# Preview Solution CBR-2518-2

## Load Lock Clamp Breaking - VN (4) - PR (4)

Published 11 November 2025

The purpose of this CBR is to address a issue that has been reported of the load lock clamp breaking.

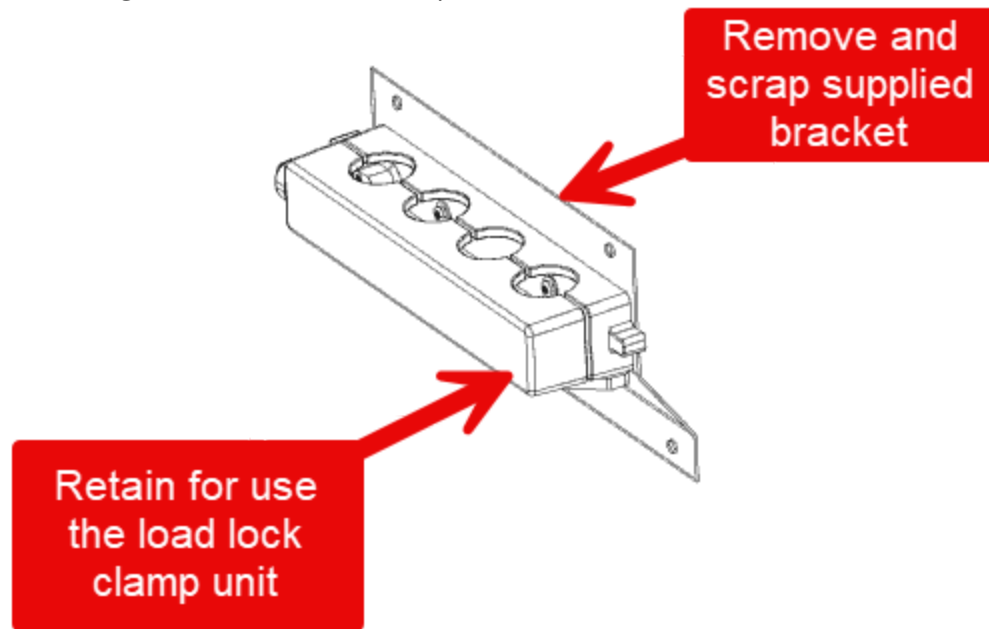
2. You will need to drill new holes in the existing bracket. Please use the template below.

The left reference hole will line up with the farthest hole in the bracket.

3. Drill hole's with a 8mm drill bit.

4. Once you have drilled the holes needed, remove the bracket from p/n 20437618. You will need to retain hardware that held the load lock clamp to its bracket for mounting of the unit. Please scrap the unused bracket.

5. Install 20437618 clamp on to the bracket you drilled. Torque the bolts to 10Nm (8 lb<sub>f</sub>-ft)
